Access Compliance Report

Public Rights-of-Way

(Curb Ramps)

Intersection ID: 49400	Main Street: OLD_CONCORD_RD	Cross Street: LAUREN_VILLAGE_DR	Location: W
ADA ID: 545D46ED6117	Ramp Type: Perp	Initial Pass/Fail: Fail	Overall Compliance: No
Severity Score: 8.75			
Codes/Mitigation Info/Possible Solution		Field Measurements/Component Compliance

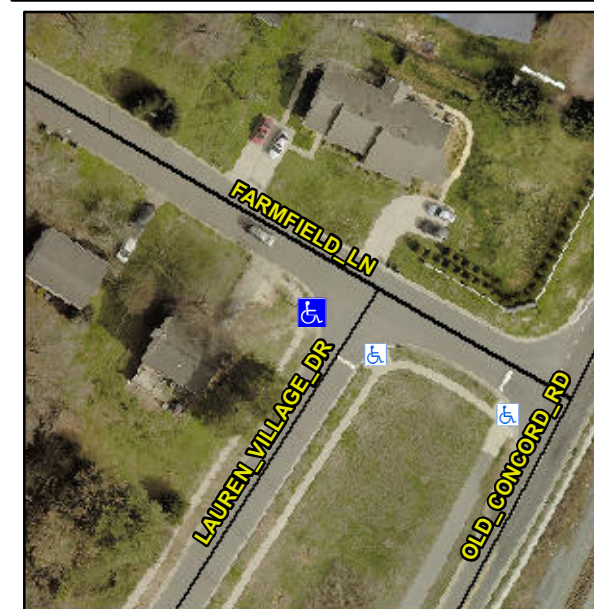
Not Found, R304.5.1

Compliance	Description	Data	Compliance	Description	Data
N/A	Ramp Length (in)	52.0	Yes	Ramp Slope (%)	5.7
No	Ramp Width (in)	47.0	Yes	Ramp XSlope (%)	1.9
N/A	Flare Type LT	N/A	N/A	Flare Type RT	N/A
N/A	Flare Slope LT (%)	N/A	N/A	Flare Slope RT (%)	N/A
N/A	Flare Traversable LT?	N/A	N/A	Flare Traversable RT?	N/A
N/A	Landing Length (in)	N/A	N/A	DWS Provided?	N/A
N/A	Landing Width (in)	N/A	N/A	DWS Contrast?	N/A
N/A	Landing Slope (%)	N/A	N/A	DWS Length (in)	N/A
N/A	Landing X Slope (%)	N/A	N/A	DWS Full Width?	N/A
N/A	Landing Curb? (Y/N)	N/A	N/A	DWS Offset (in)	N/A
N/A	Shared Landing?	N/A			
N/A	Gutter Ponding?	N/A	N/A	Gutter Slope (%)	N/A
N/A	Gutter Lip Ht (in)	N/A	N/A	Gutter X Slope (%)	N/A
N/A	Painted X Walk1?	No	N/A	Painted X Walk2?	N/A
	X Walk 1 Direction	To S		X Walk 2 Direction	N/A
N/A	X Walk 1 Width (in)	N/A	N/A	X Walk 2 Width (in)	N/A
	X Walk 1 Slope (%)	2.1		X Walk 2 Slope (%)	N/A
	X Walk 1 X Slope (%)	4.4		X Walk 2 X Slope (%)	N/A

Remove & Replace Entire Ramp.
